**Report No.** 43-02

**Address of property inspected:** Artane, Dublin 5.

This report has been prepared to ascertain the source and provide possible remedies for the presence of moisture stains on the party wall between our clients rear extension, and a similar rear extension to the adjoining property to the south-west.

**Photo looking at roof edge/parapet**

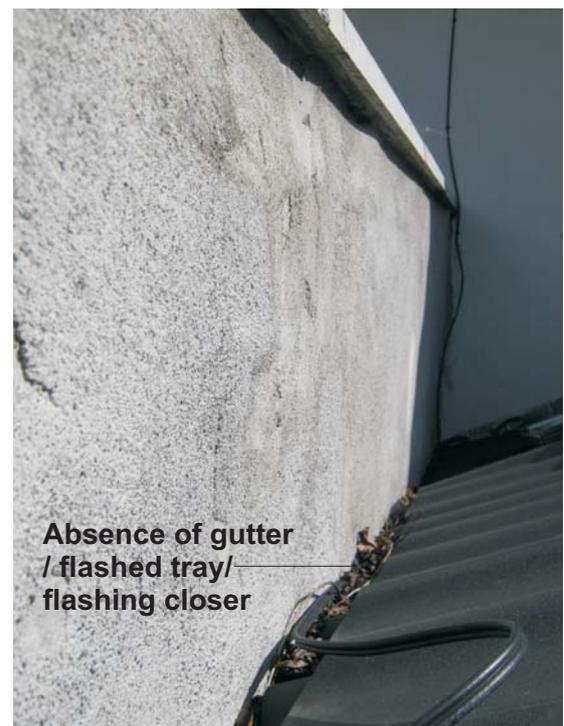
On inspection of the junction of the roof, and the parapet wall, it appears that there is no valley gutter installed to allow water to run off the roof correctly.

In the event of any reasonable rain shower, water will run directly on to the parapet wall. The nature of the roofing material, which has a relatively smooth surface, allows water to move at a much faster rate across it, unlike materials such as slate or concrete roof tiles, thus compounding the problem.

**Photo looking in at parapet wall**

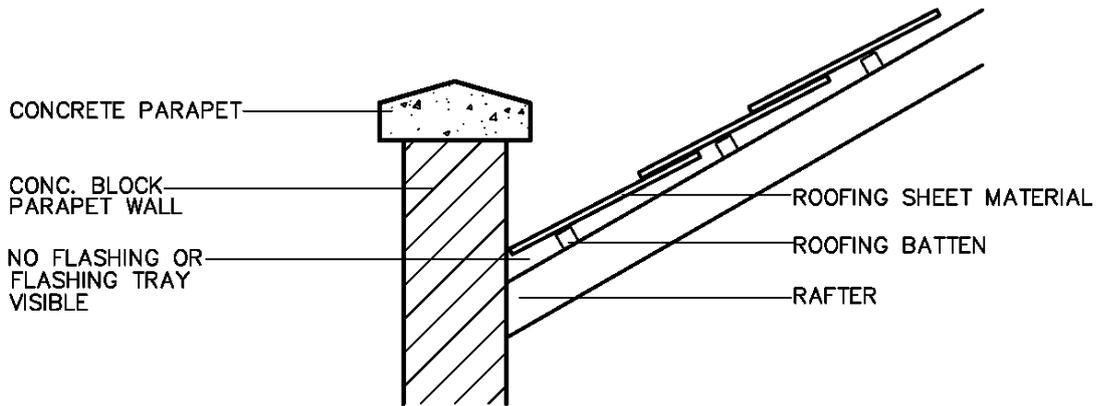
The incorrect valley detail has allowed water to flow onto and down the boundary wall of our clients property resulting in staining of the plasterwork in his kitchen.

**PARAPET DETAIL (N.T.S.) (as visible on site)**

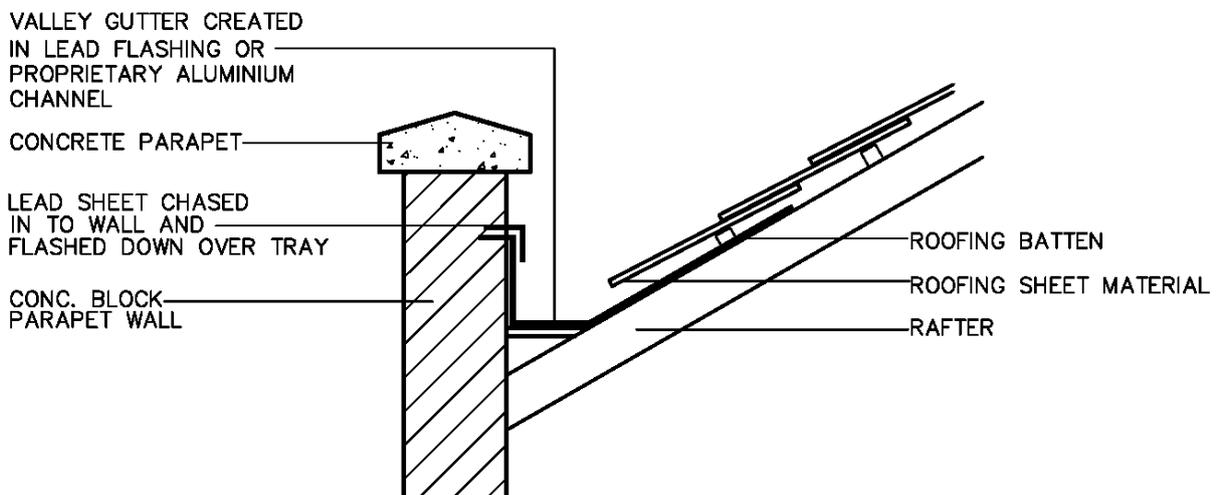
The parapet detail as it appears to be constructed, and a correct detail for this type of construction are indicated below.

Our client wishes that these works be remedied by a competent, suitably qualified roofing contractor and that a correct valley detail as previously specified be installed on the boundary wall as soon as possible to prevent any further damage to his property.
